DISCUSSION OF PROCEEDINGS - SEPARATES

STRUCTURAL DIVISION

Discussion of "ANALYSIS AND TESTS OF A CYLINDRICAL SHELL ROOF MODEL"

by Bruno Thürlimann and Bruce G. Johnston (Proc. Sep. 434)

Fig. 20.—Experimental Deflection Curves

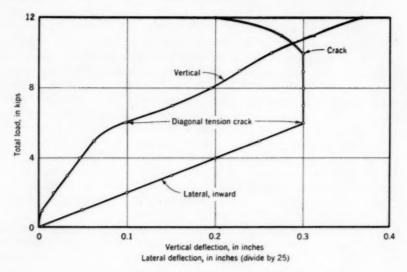
Fig. 20 provides information on the range of virtually elastic action of reinforced concrete shells. The lateral deflections of the shells were entirely consistent (in direction and order of magnitude) with elastic theory, up to the load at which initial diagonal-tension cracking developed. The average vertical deflection at the center of the two edge beams showed a similar characteristic, with the customary early lag in deflection prior to tensile cracking at the level of the longitudinal steel in the edge beams.

BRUNO THÜRLIMANN7 AND BRUCE G. JOHNSTON,8 M. ASCE.-In Fig. 20

Mr. Ernst has shown that thin-shell models made of cement mortar behave elastically up to the cracking load.
